Terry Pettus Park Renovation

Meeting Summary

This was the Seattle Design Commission's (SDC) second review of the Terry Pettus Park Renovation Project. The purpose of this meeting was to review the schematic design phase (60% design) for the project. The SDC voted, 8-1, to approve the schematic design for the Terry Pettus Park Renovation project with several conditions and recommendations.

Figure 2: Updated design proposal

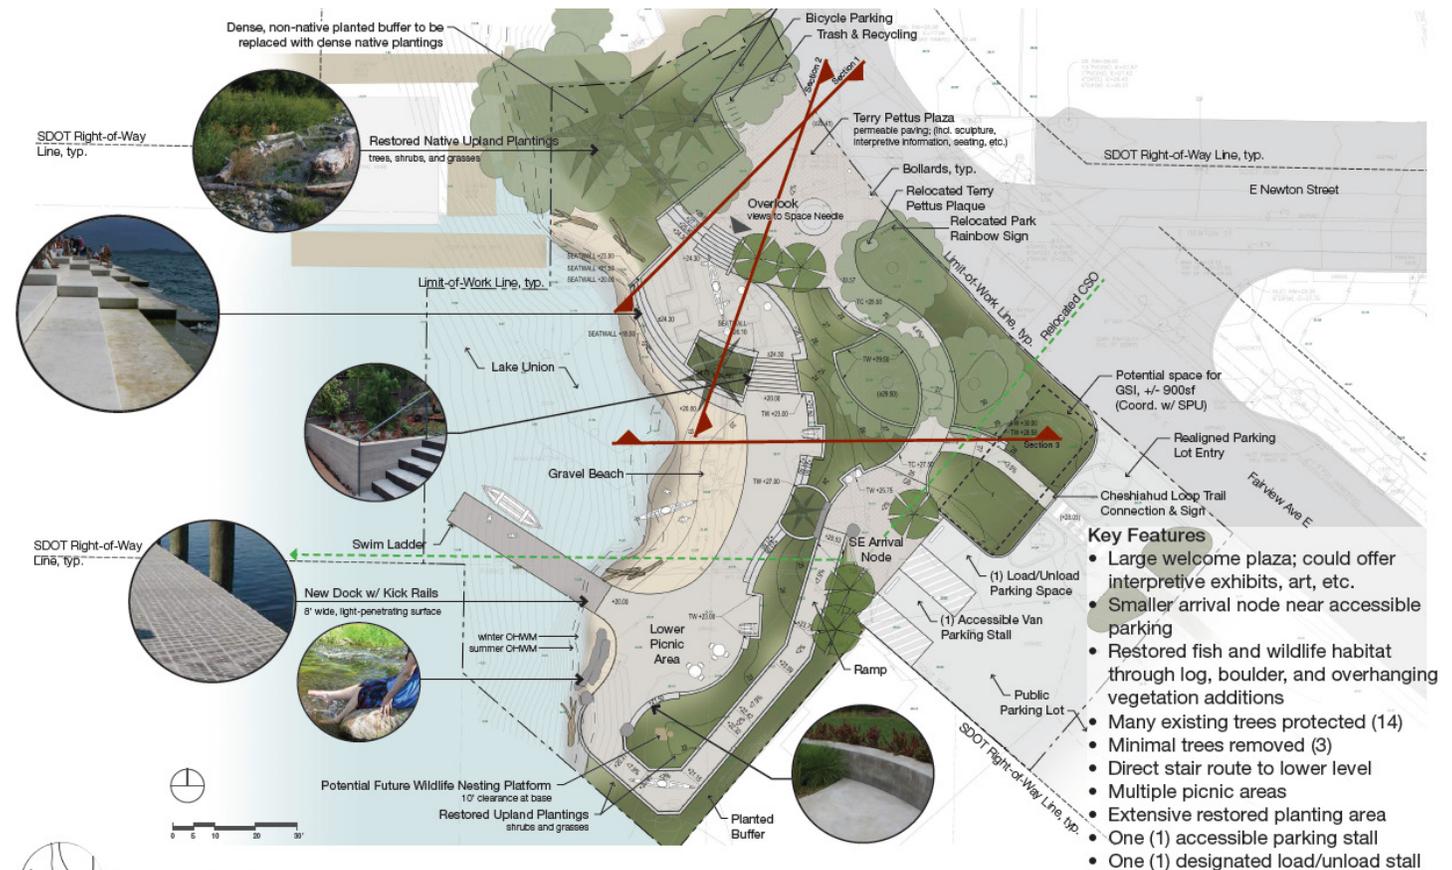
The Commission then commented on the development of specific project elements. Commissioners appreciated the inclusion of specific elements such as kayak storage and the osprey nest. The Commission recommended the project team provide a water fountain on site or provide wayfinding to direct users to the nearest off-site water fountain. The Commission then raised concern over the sharp turn along the pathway

between the loading area and dock and encouraged the project team to soften the edge so to not negatively affect users carrying kayaks or other large items.

The Commission then discussed concerns with limited access to the middle terrace. Commissioners stressed the importance of providing a space that is accessible for all users and recommended the team either provide universal access to the middle terrace or remove the terrace from the design proposal. The Commission then conditioned the team address this issue during the subcommittee review that will address overall design developments.

The Commission then encouraged the project team to continue to further soften the edges and materials used as they approach the shoreline. Commissioners also identified the boat slide as an opportunity for an artistic, culturally responsive element and encouraged the team to use a material such as wood to build the slide. The Commission then reiterated its concern with the design and dimension of the loop trail entering the park and encouraged the project team to use a material such as a tactile paving strip to provide a physical cue for cyclists entering into the park.

I am also concerned at the dimensions of the loop trail at the limits of the project and going through the park. As designed, the dimensions do not adequately address the interactions and potential conflicts between the park users and the cyclists and pedestrians moving along the trail through the park. It would help to know if the trail through the park is considered a spur of the trail or the mainline of the trail.

1. Return for a subcommittee meeting to review how the proposed design has continued to develop. Specific details to be reviewed include the continued development of the middle terrace design & access, plans for art integration, and continued coordination with SDOT and SPU in the development of the adjacent ROW design and SIP process, integration of the loop trail to the City trail system, and GSI projects.

1. Evaluate opportunities for providing universal access to the middle terrace; or consider removing the middle terrace.
2. Continue to conduct community outreach. Strongly consider measuring demographics to have a better understanding of who is responding and participating and how their input is influencing the overall design.
